ADDENDUM NO. 4

January 30, 2023

Three Rivers Community Schools – Three Rivers Middle School Additions and Renovation

This Addendum consists of Pages ADD 4-1 through ADD 4 - 3, Attached RFI Log, Substitution Request, and GMB Architecture and Engineering Addendum No. 4, dated January 26, 2023, consisting of 4 pages, Reissued Specification Sections; 08 71 00 – Door Hardware, 09 22 16 – Non-Structural Metal Framing, and 09 65 19 - Resilient Tile Flooring, New Sheet; S3.1E, and Reissued Sheets; G0.00, G1.01, G2.01, C8.01, A1.1E, A2.1E, A2.30, A5.01, A6.01, A7.03, A8.01, A8.02, M1.1D, M1.1E, M1.81, M2.1C, M2.1D, M2.1E, M3.1D, M8.01, M8.03, M8.04, M9.01, M9.02, E1.1C, E1.1D, E2.1D, E2.1E, and E7.01.

UNIT 'D' HYDRONIC PLAN
1/8\"/>

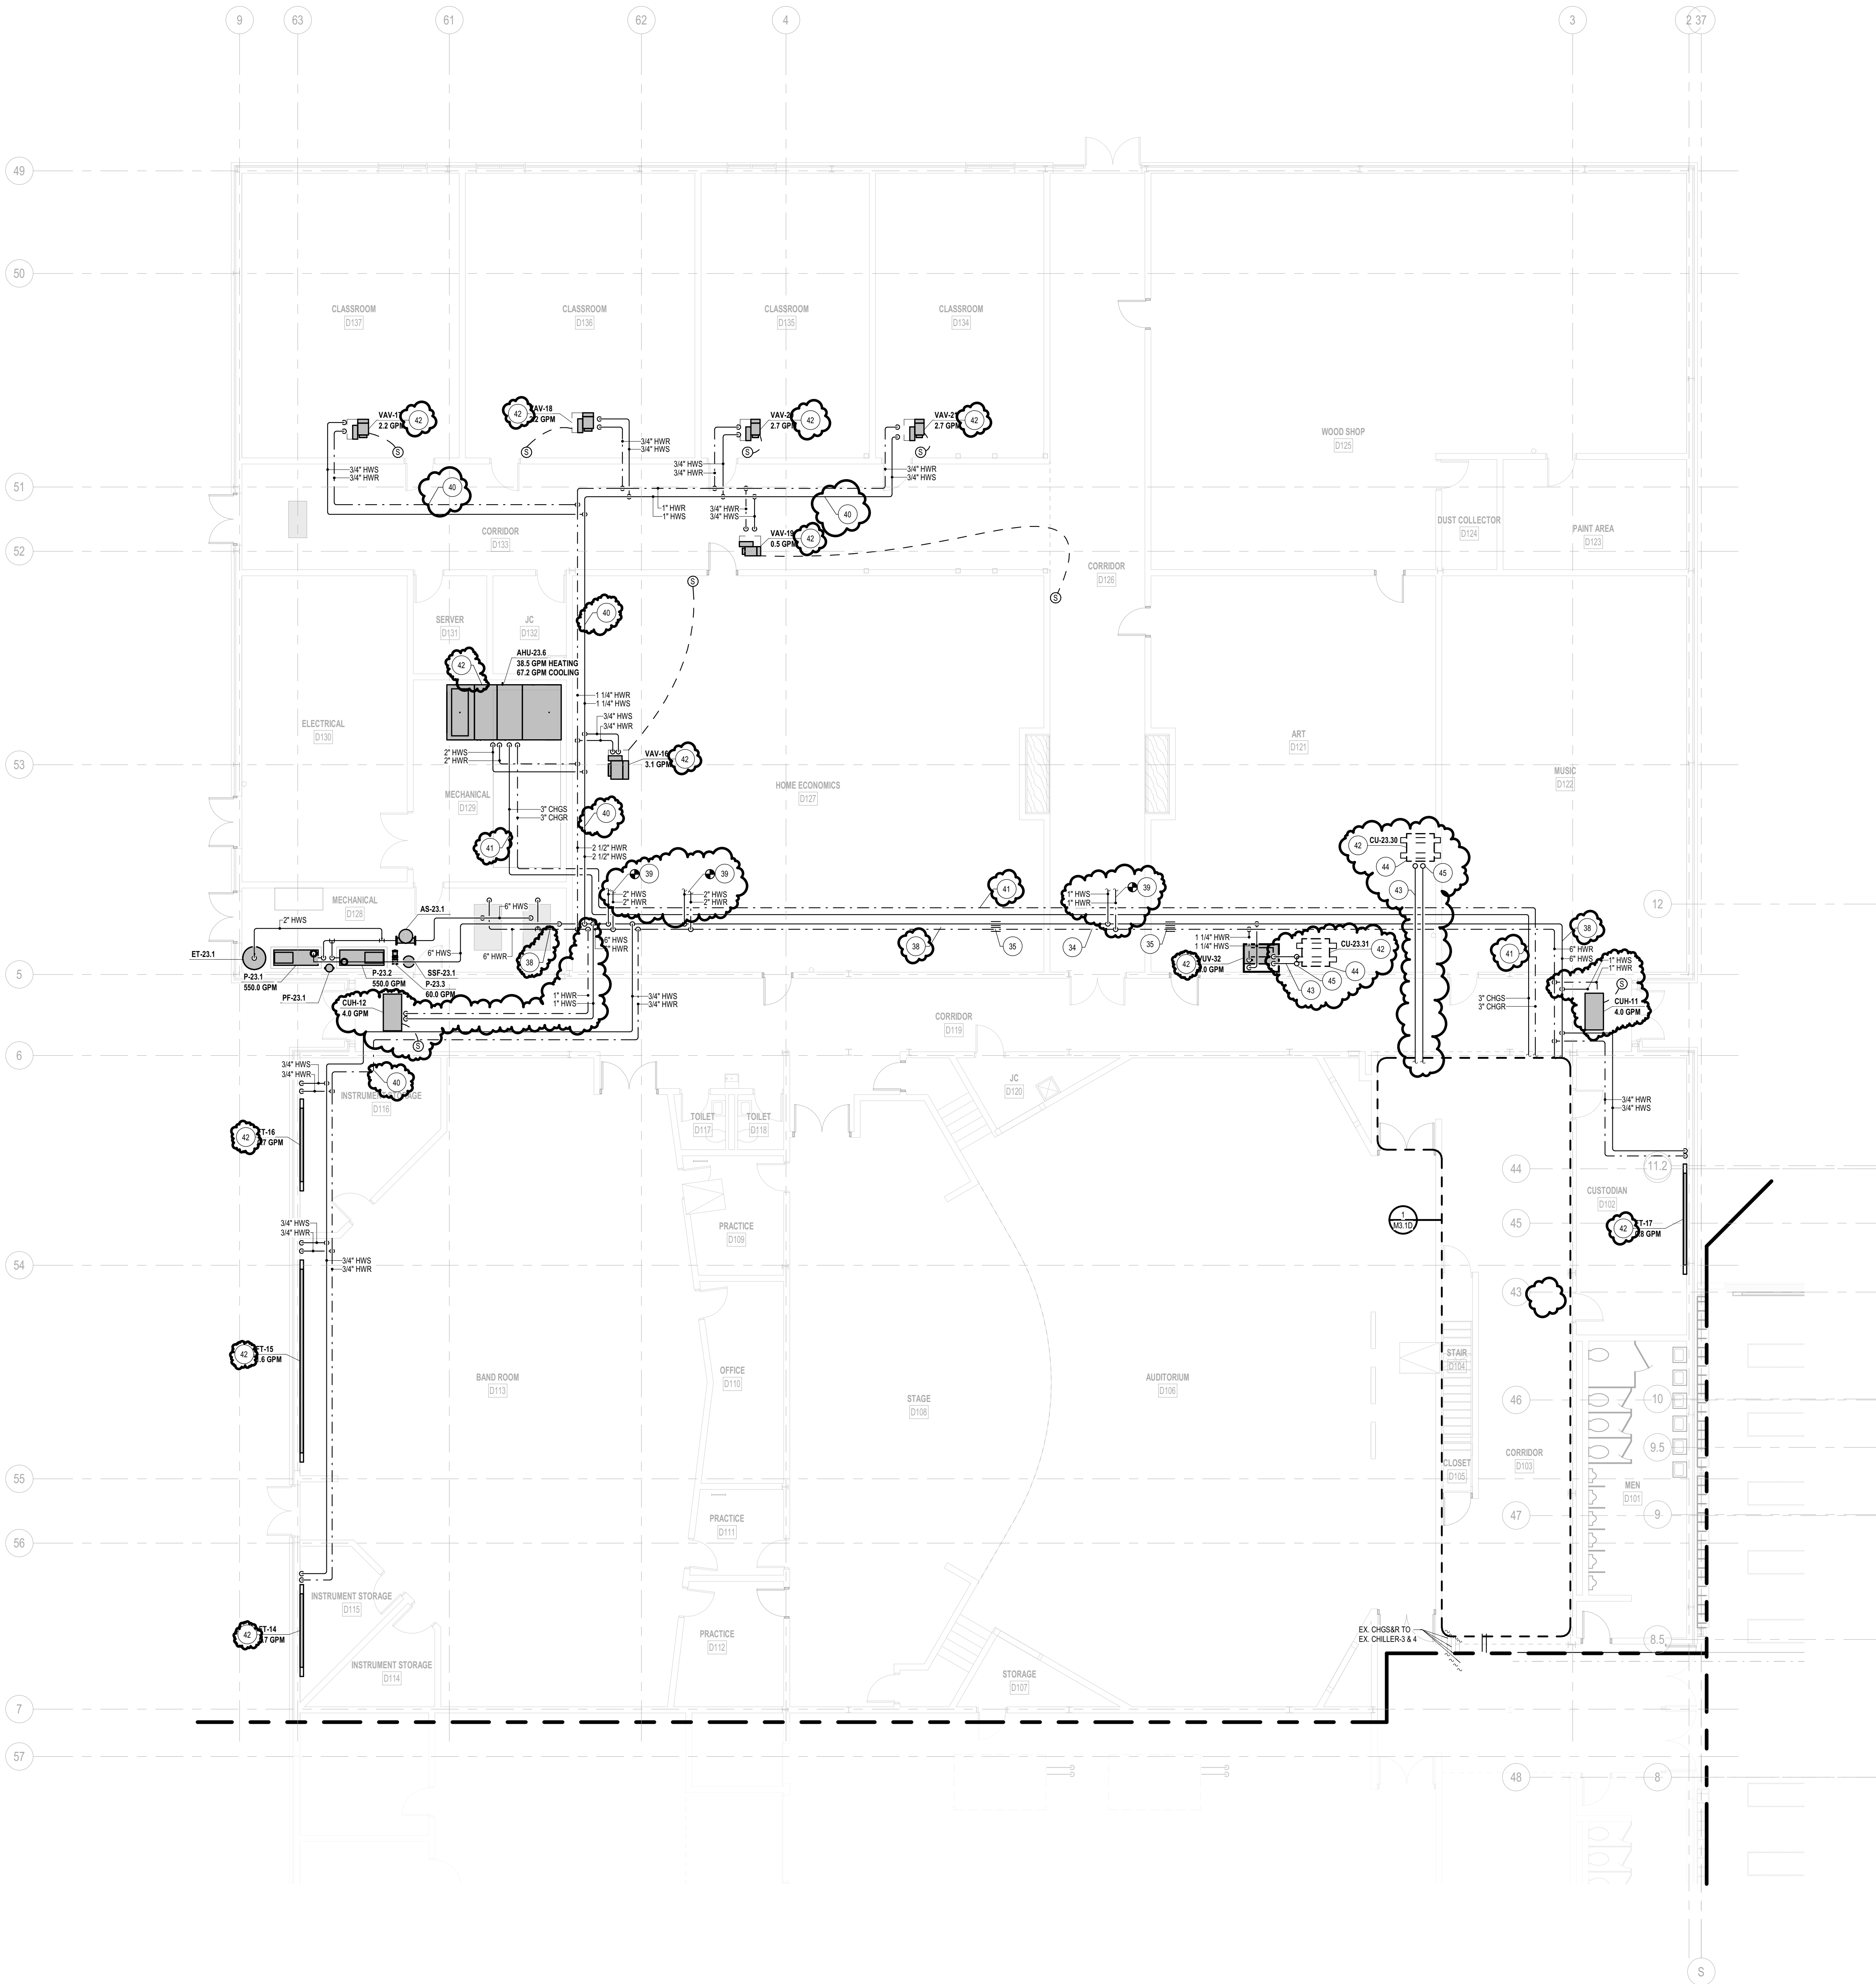
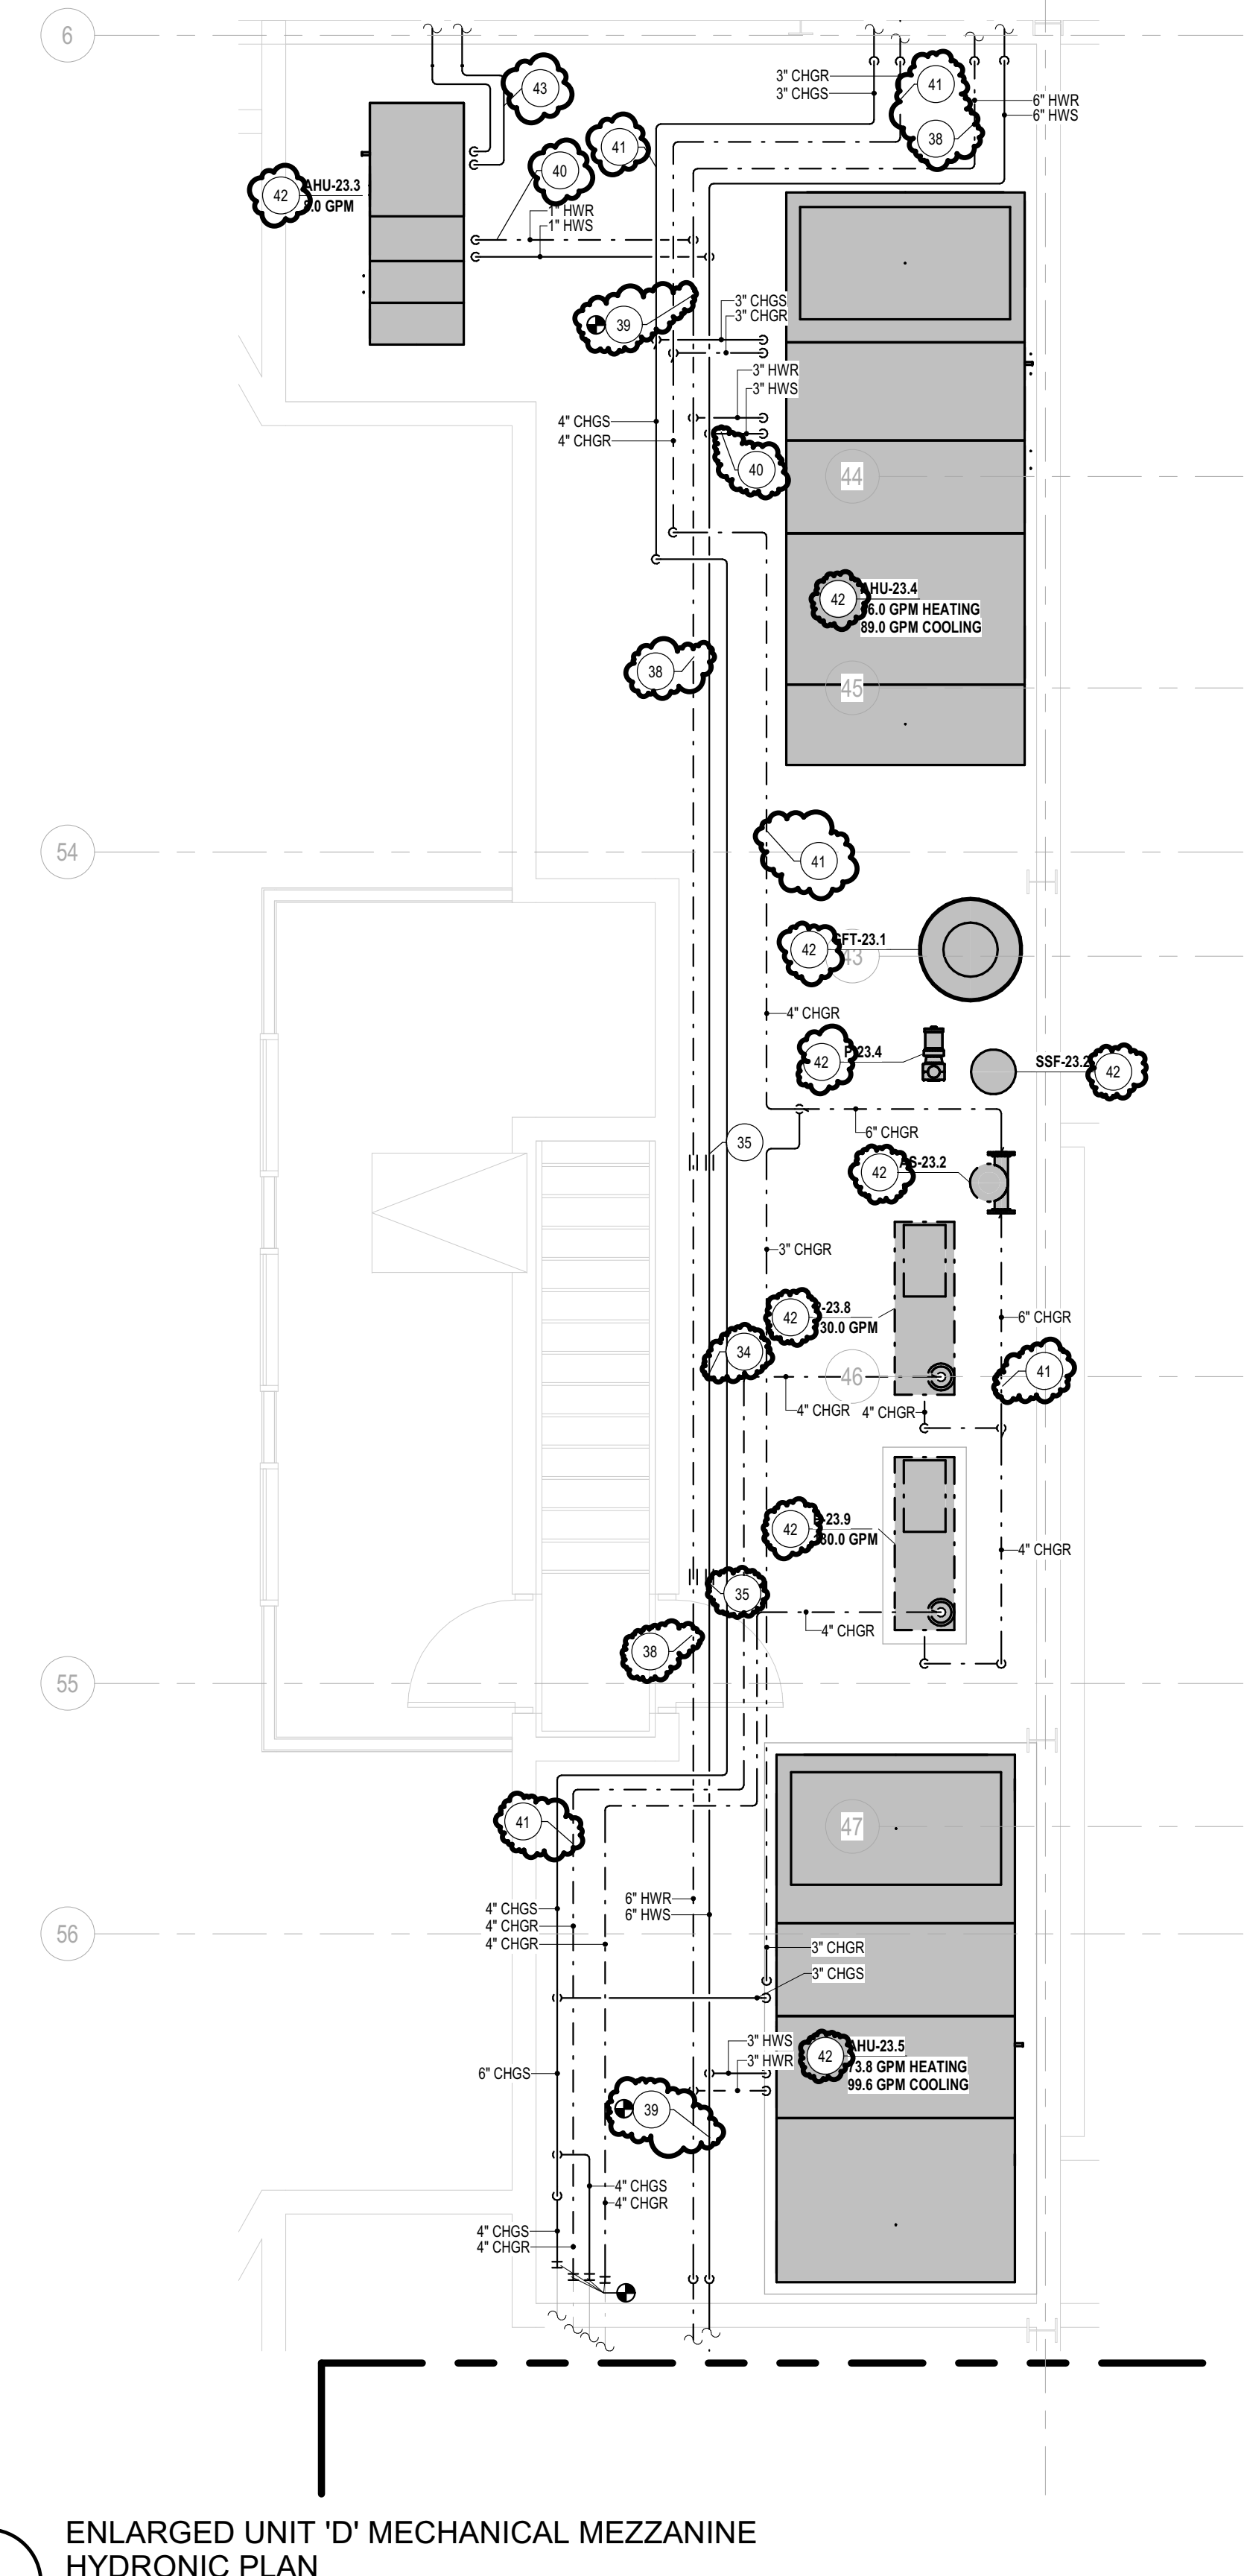
- A. Added mechanical keynotes.
- B. Added Mechanical Keynote Legend.
- C. Added new and existing hot water heating piping and sizes.
- D. Added refrigerant piping and sizes for new air-cooled condensing units.

M8.01

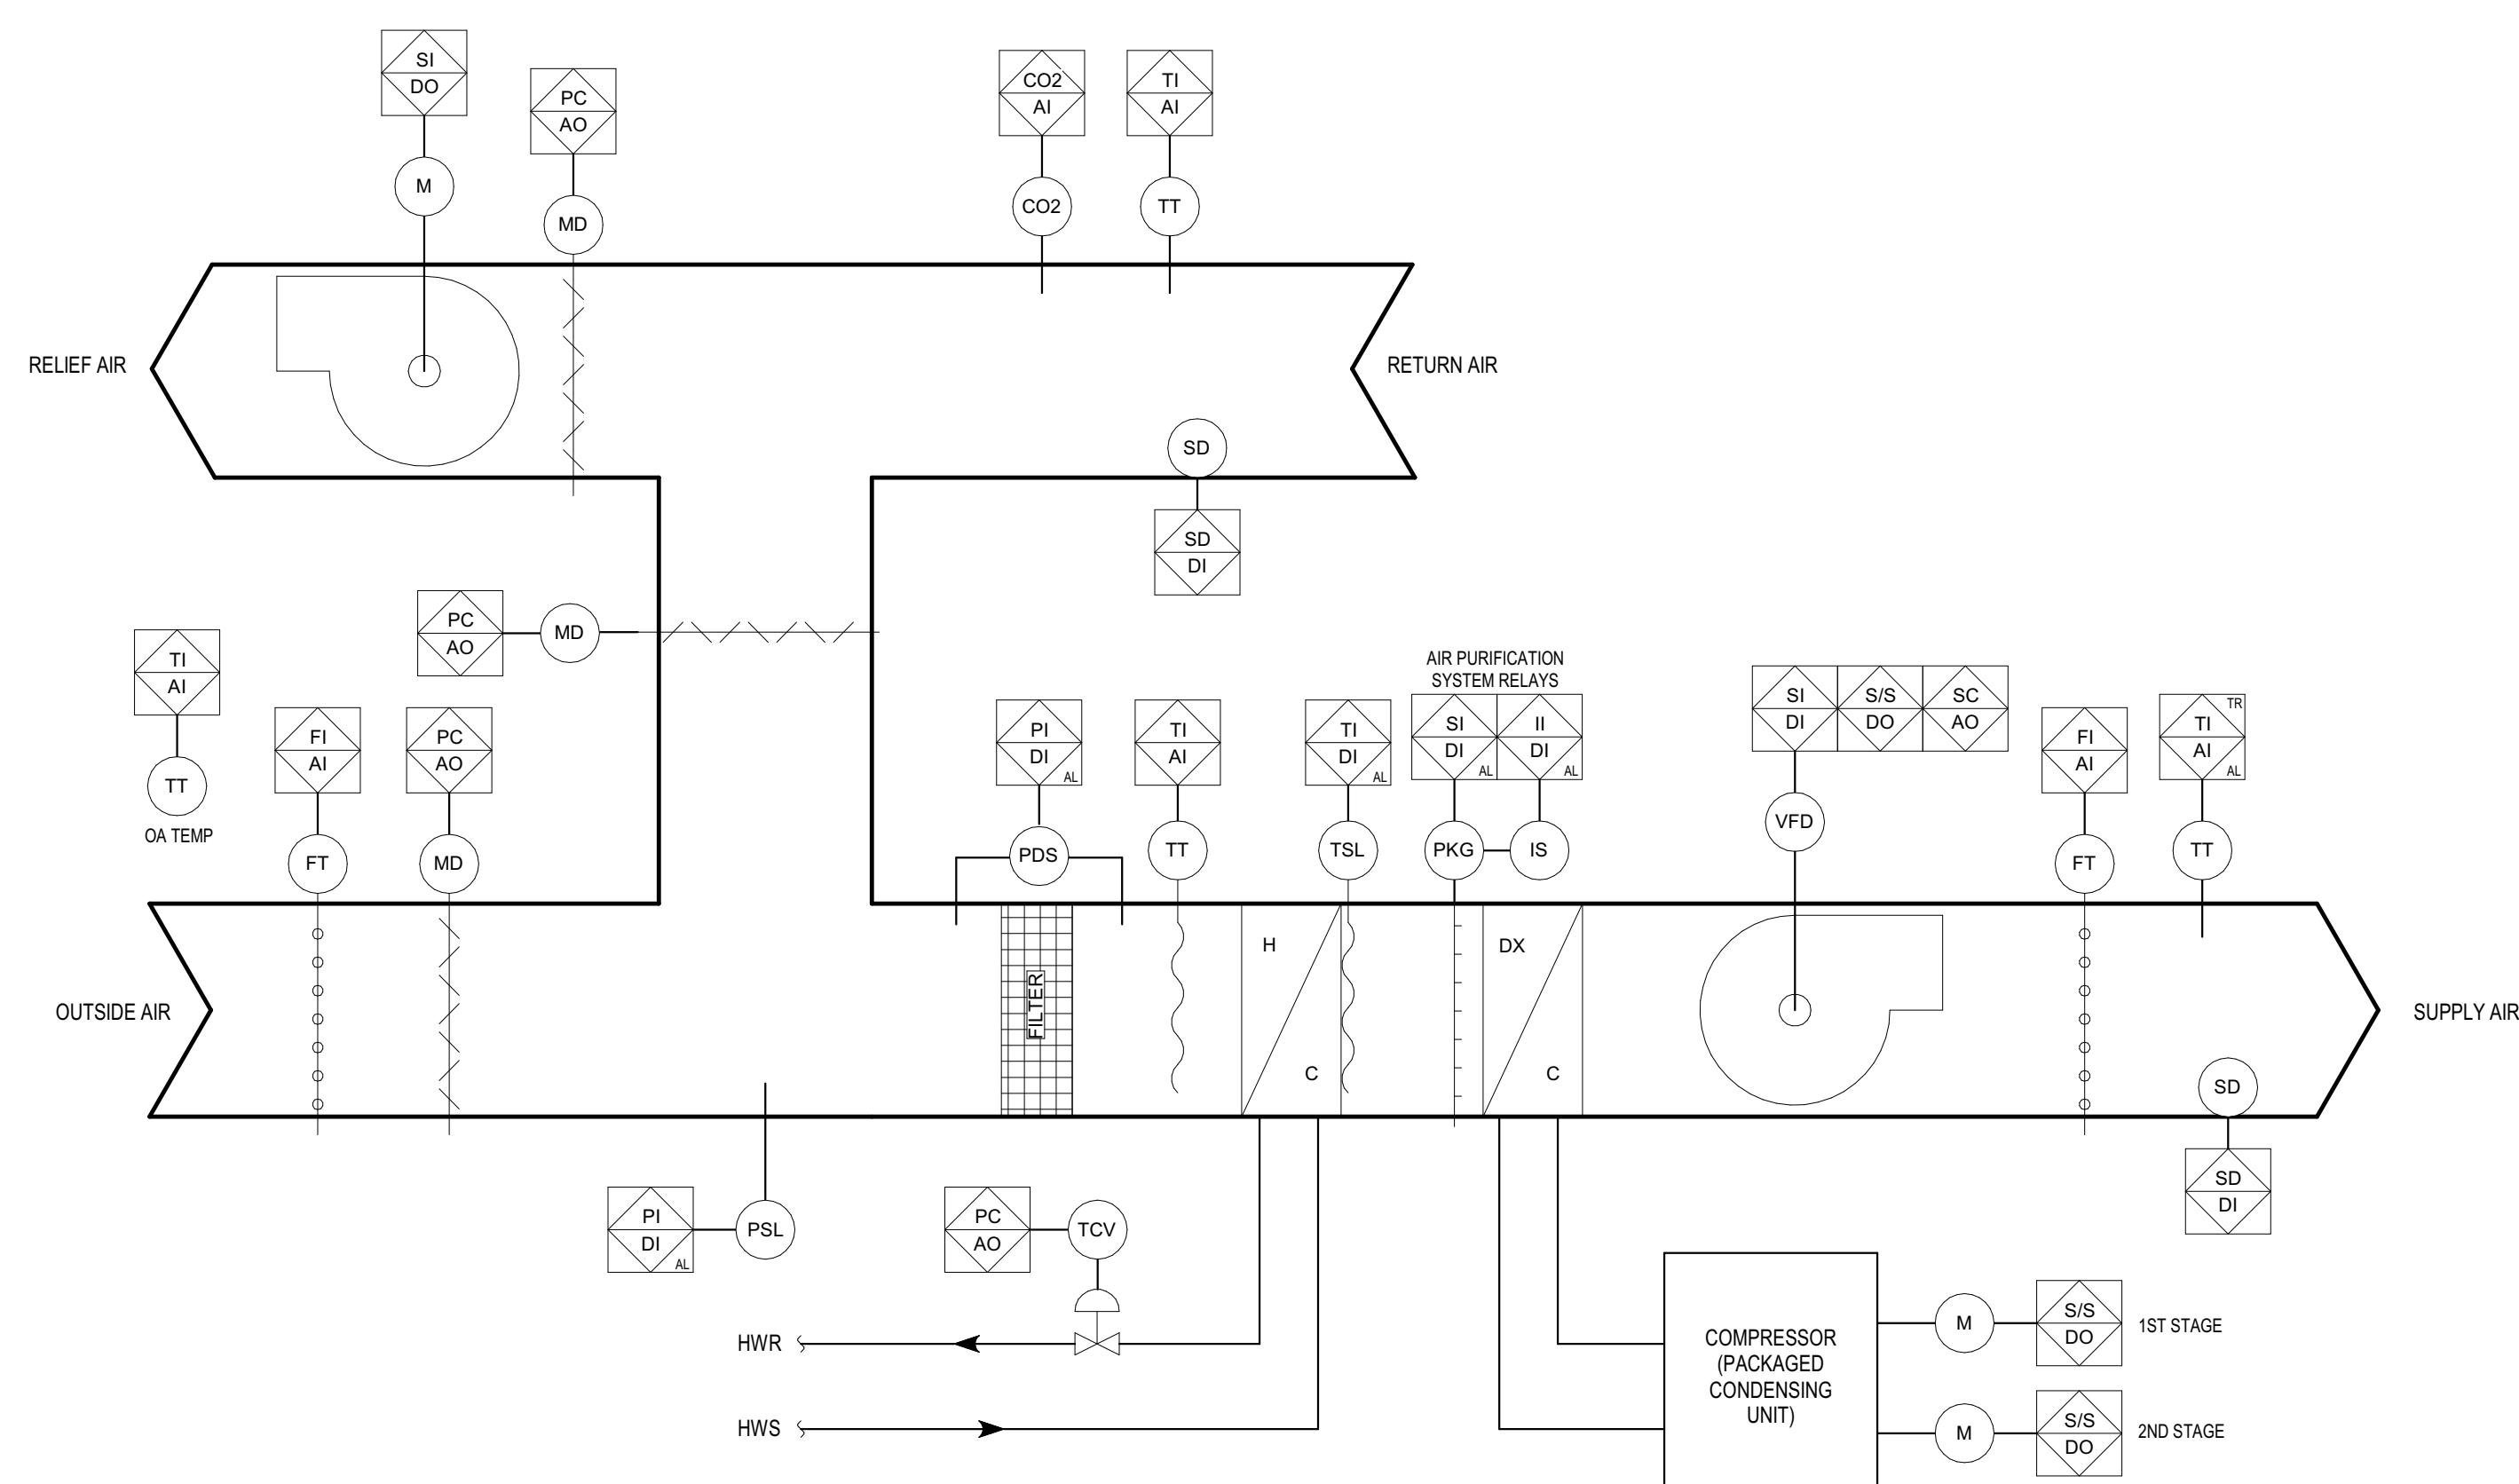
Added note to designate that the boiler system equipment controls are included under the Base Bid work.
